# **PRODUCT ADVISORY**

## **Data Sheet Specification Change for Intersil Product ISL36111\***

**Refer to:  
PA10105**

**Date: October 27, 2010**

FIGURE 8. TYPICAL APPLICATION REFERENCE SCHEMATIC FOR ISL36111

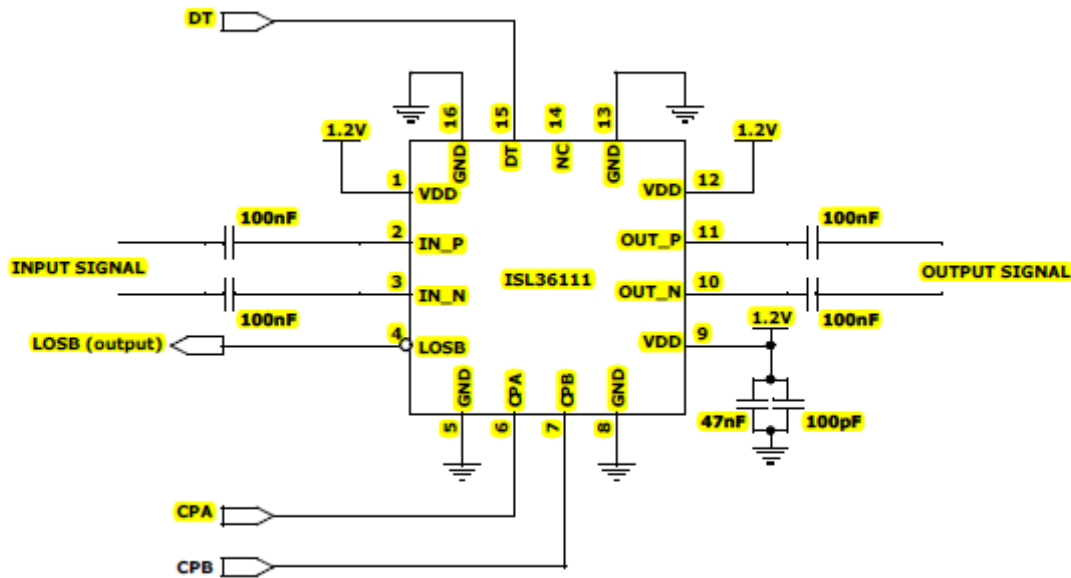
- i) The description for the VDD pin in the Pin Descriptions table was updated to recommend the use of parallel 100pF and 47nF decoupling capacitors to ground for each of these pins.
- ii) The description for the CP[A,B] pin in the Pin Descriptions table was updated to indicate the pins are read as a 2-digit number to set the boost level.
- iii) Added Figure 8 - Typical Application Reference Schematic and a section titled PCB Layout Considerations.

Typical application schematic for ISL36111 is shown in Figure 8.

- 14. See "Control Pin Boost Setting" on page 5 for information on how to connect the CP pins
- 15. See "Detection Threshold (DT) Pin Functionality" on page 6 for details on DT pin operation.
- 16. Although the filtering network is shown only for one V<sub>DD</sub> pin for simplicity, all the V<sub>DD</sub> pins need to be connected in this way.
